MCPB
Item No. 10/11
11-01-2001

PROJECTS: US 29 From South of Blackburn Road to North of Dustin Road
Mandatory Referral No. 01809-SHA-1

US 29 at East Randolph Road/Cherry Hill Road
Mandatory Referral No. 01810-SHA-1

REVIEW TYPE: Mandatory Referral

Relocated US 29 Bridge
over MD 198

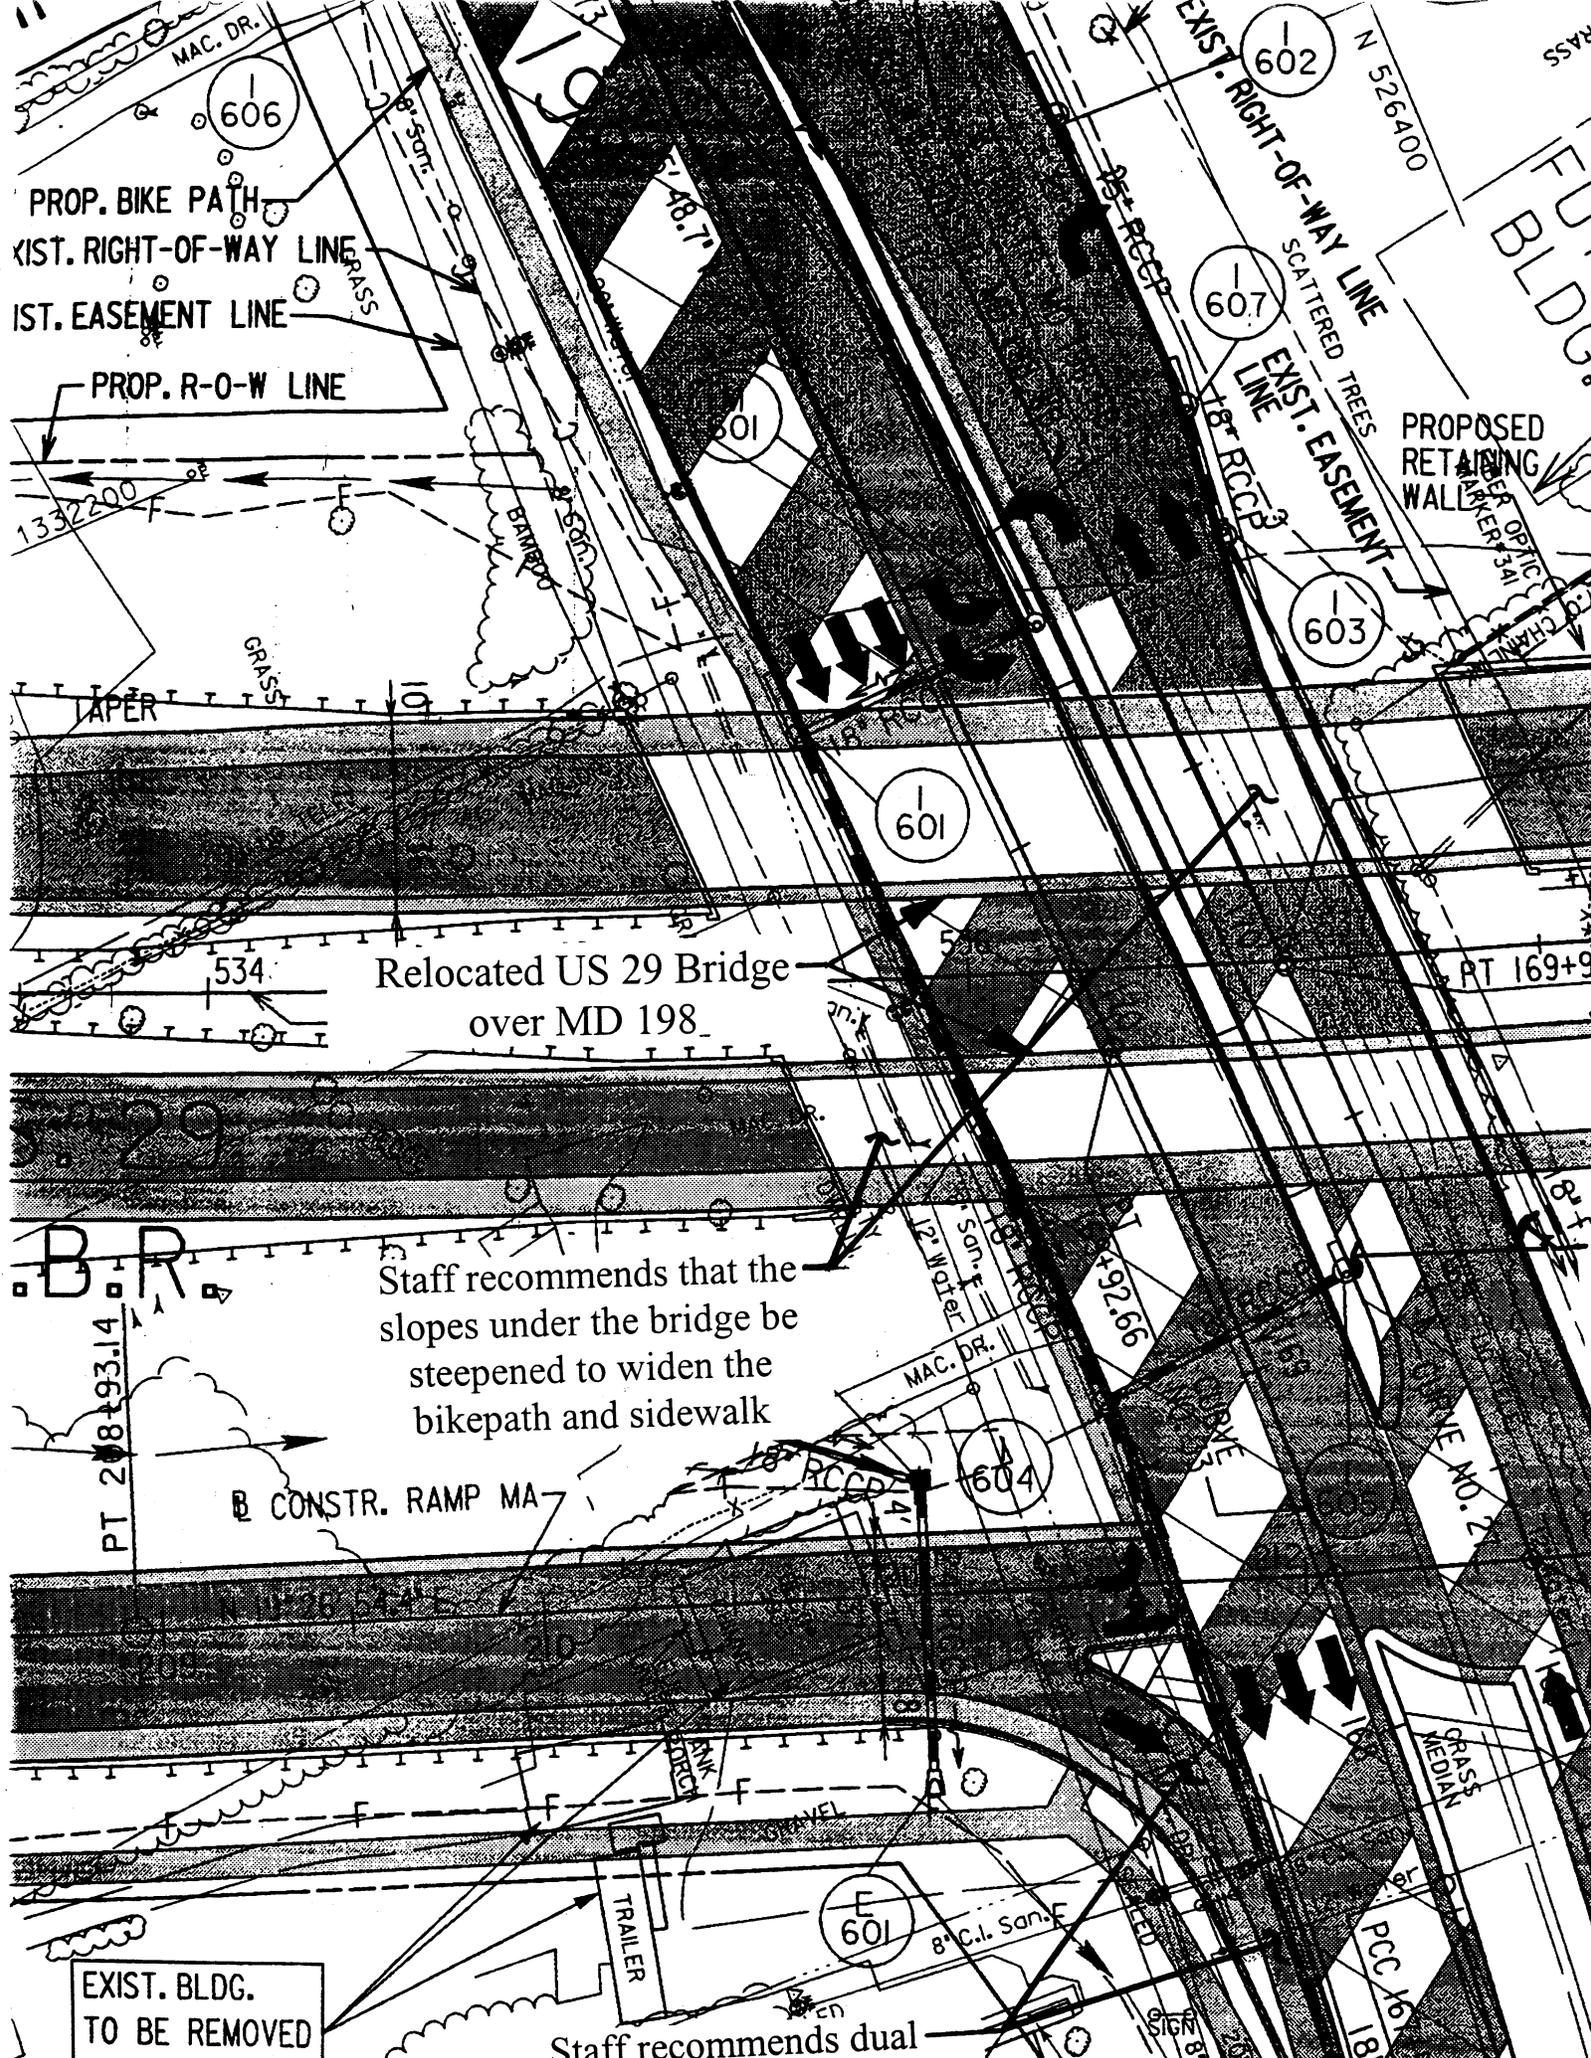
Staff recommends that the
slopes under the bridge be
steepened to widen the
bikepath and sidewalk

Staff recommends dual

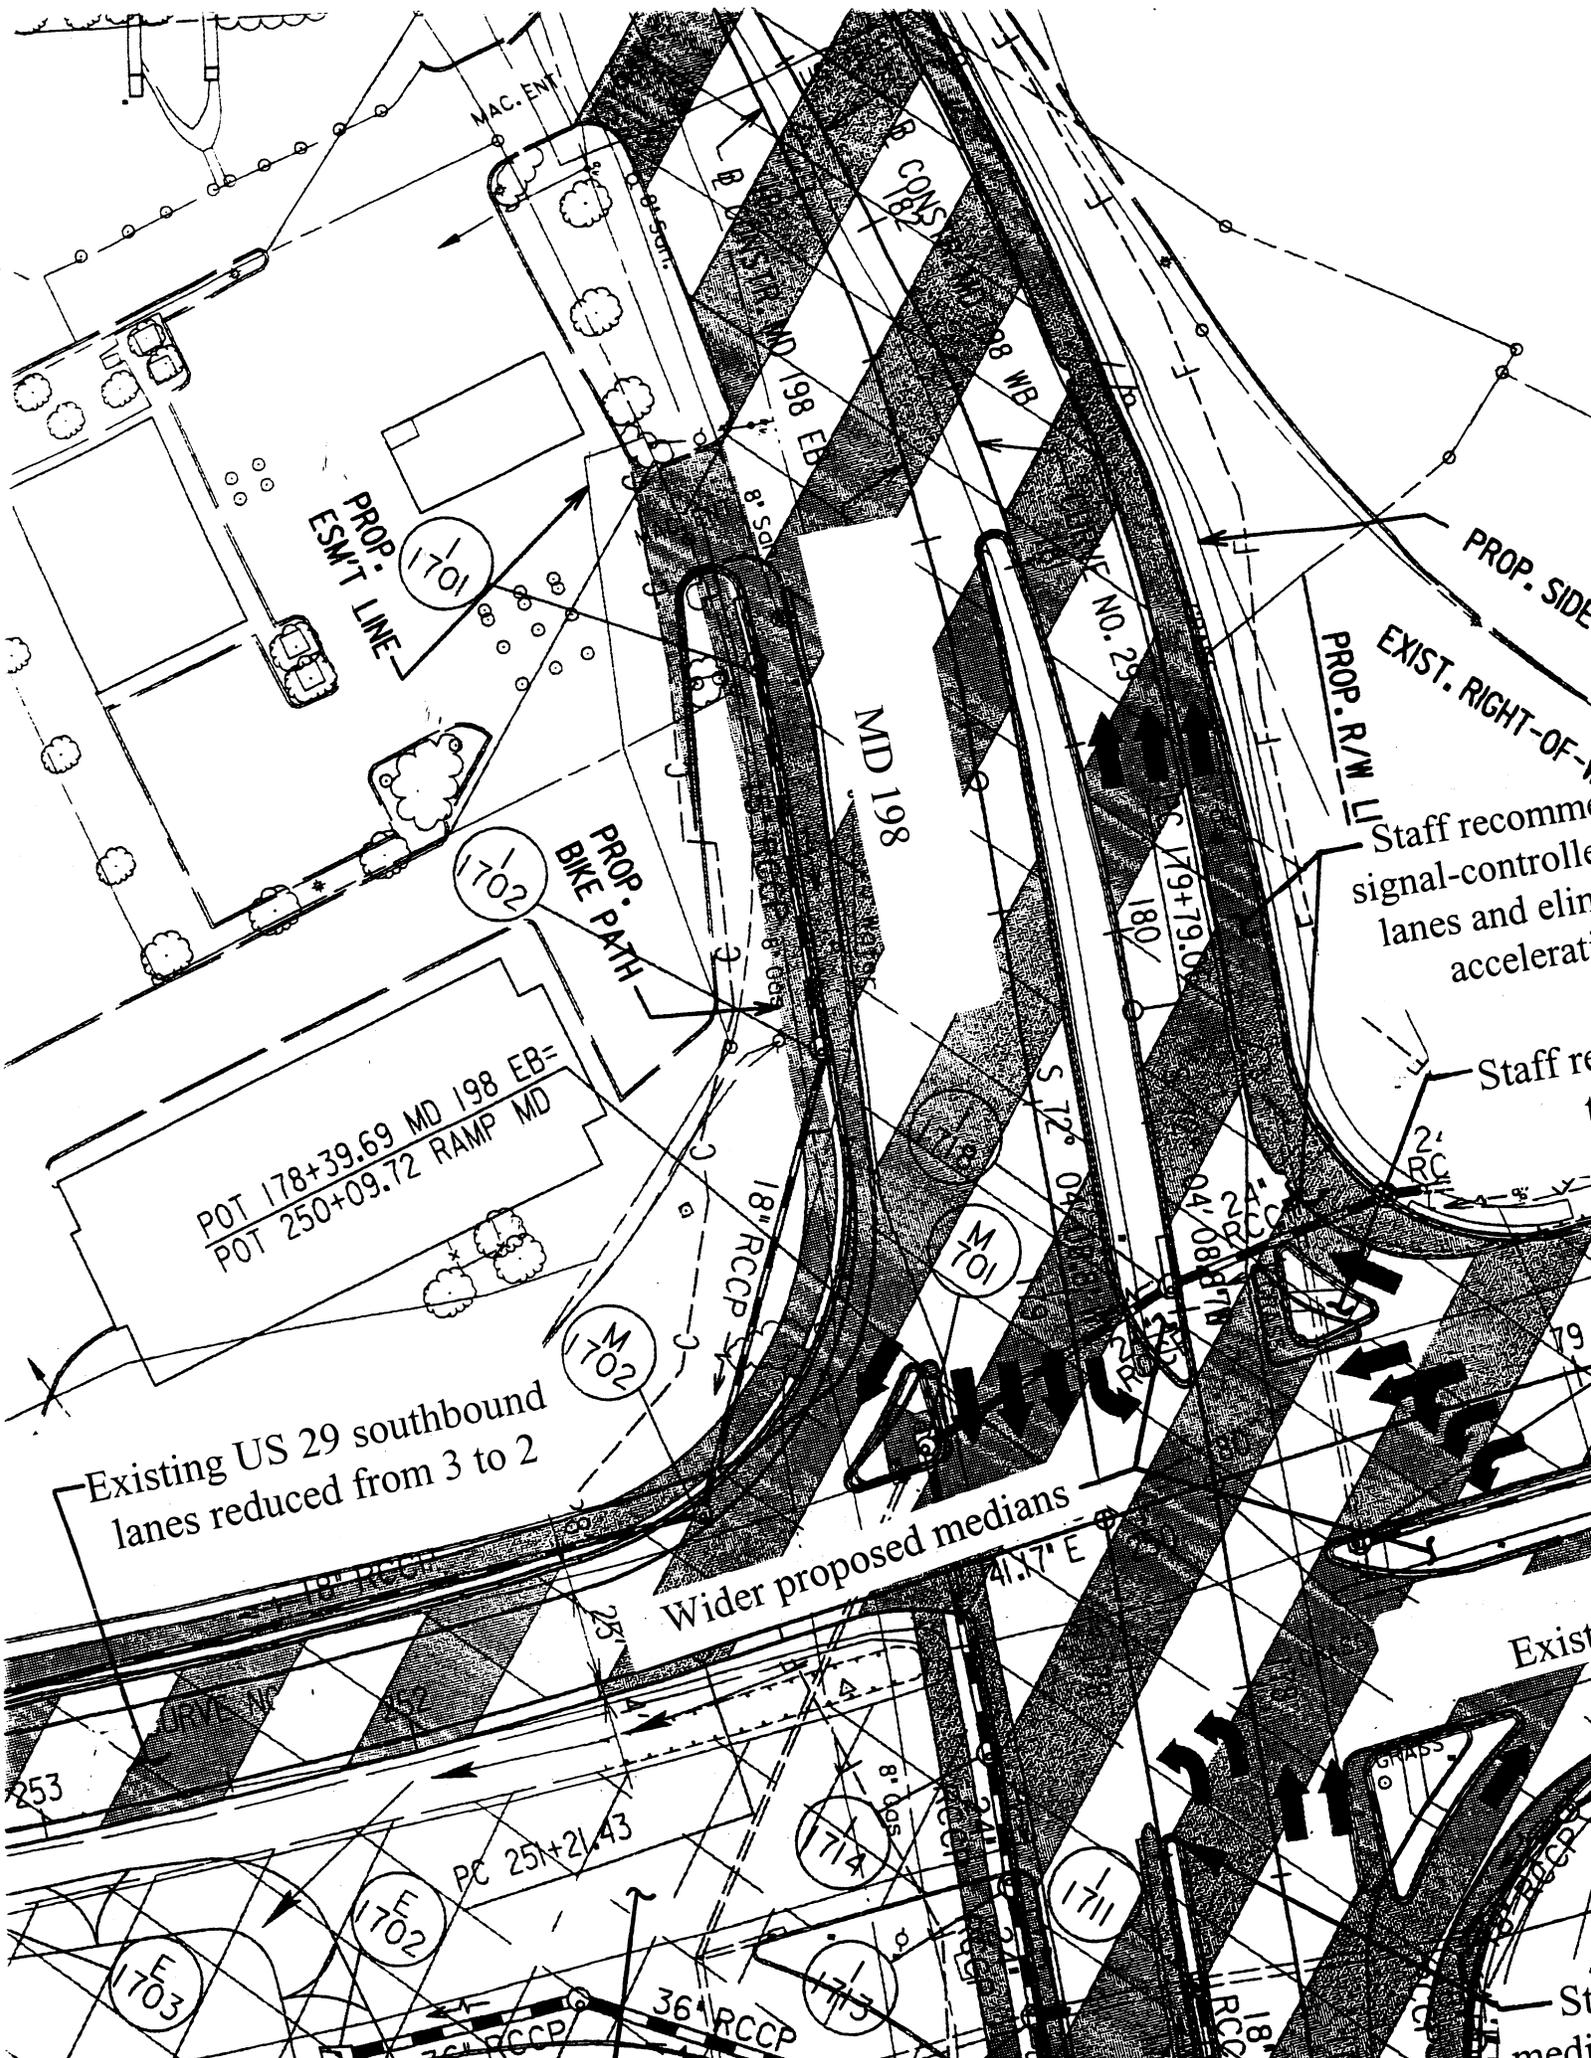
Existing US 29 southbound
lanes reduced from 3 to 2

Wider proposed medians

Staff recommend
signal-controlled
lanes and elim
acceleration

Staff re
tr

Proposed Ramps to and from
Park-and-Ride Lot along
southbound Relocated US 29

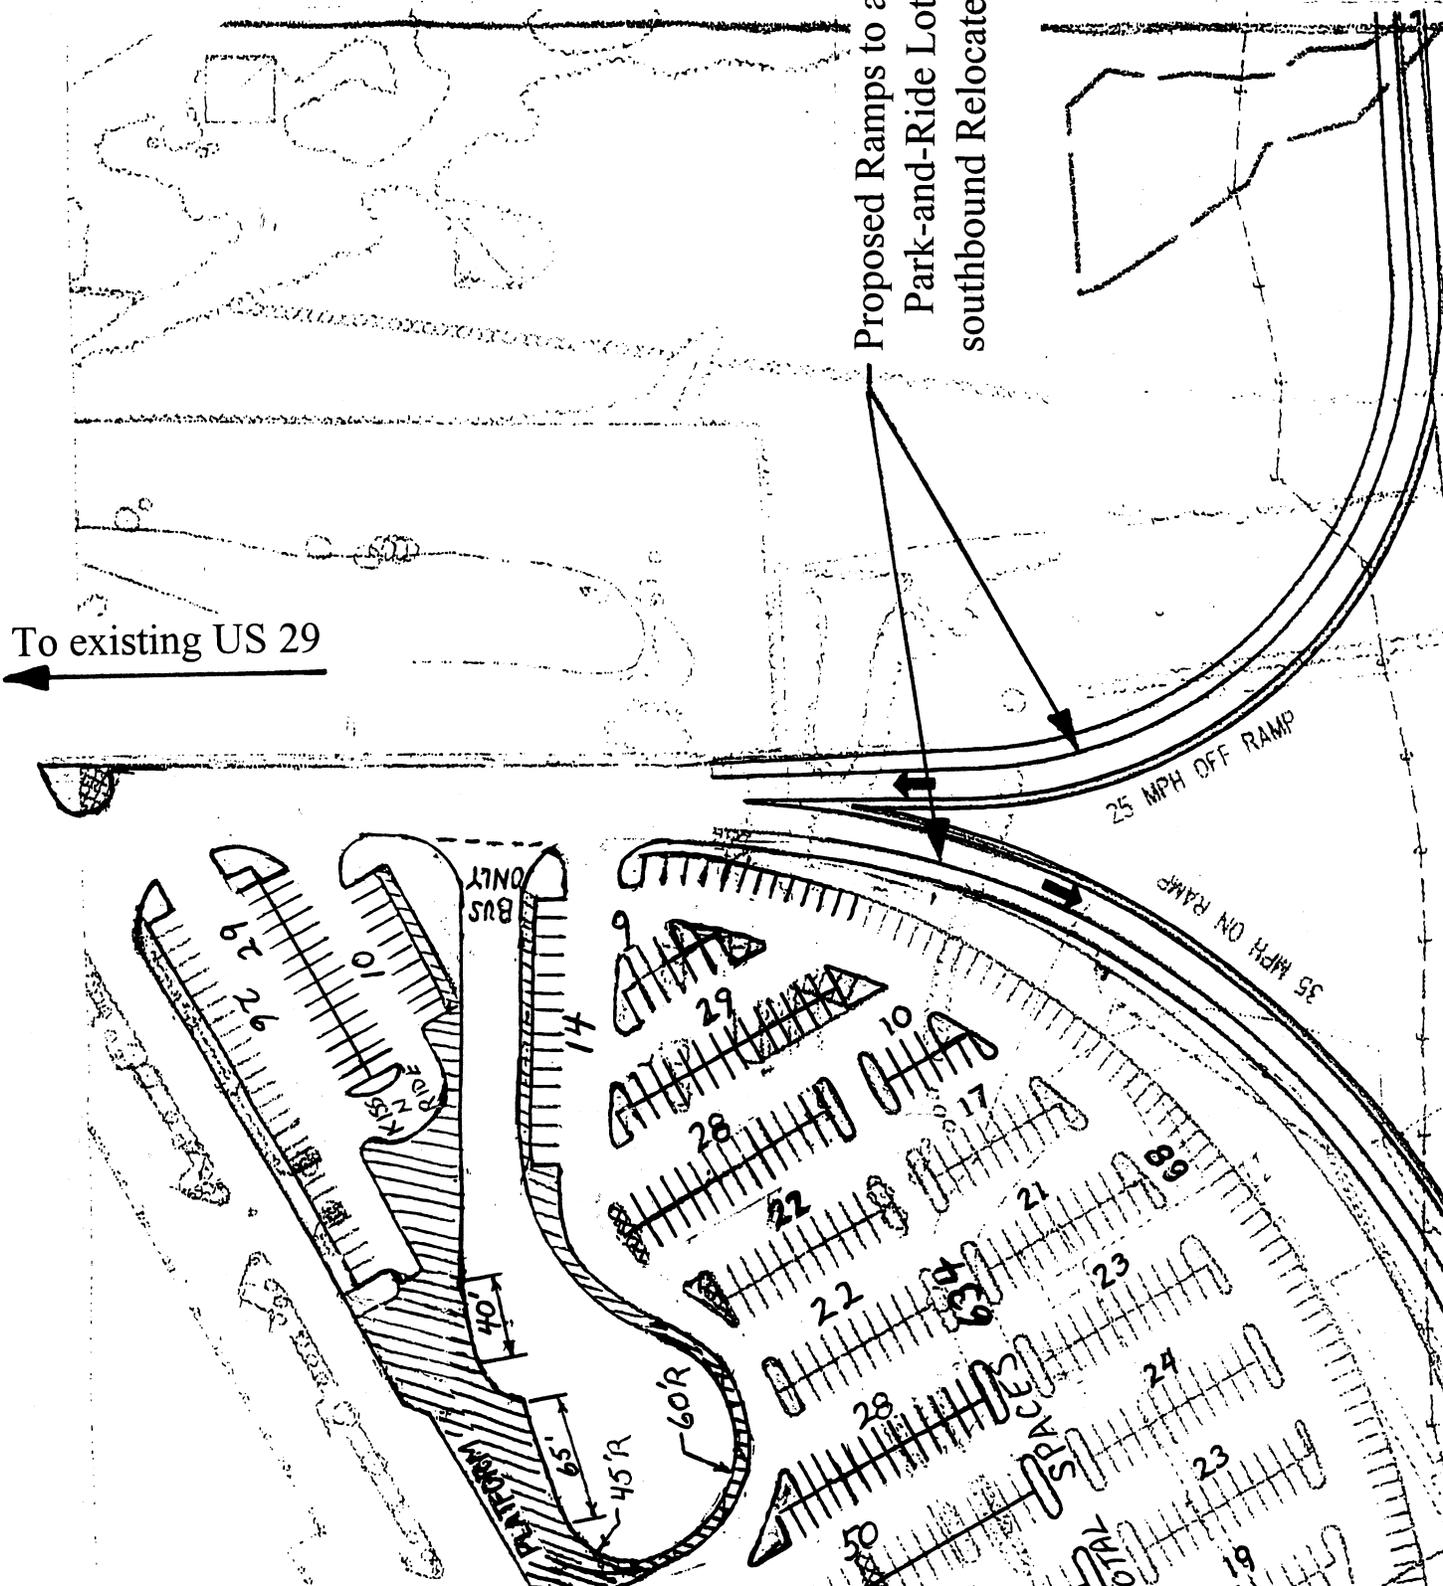
Existi

Sta
media
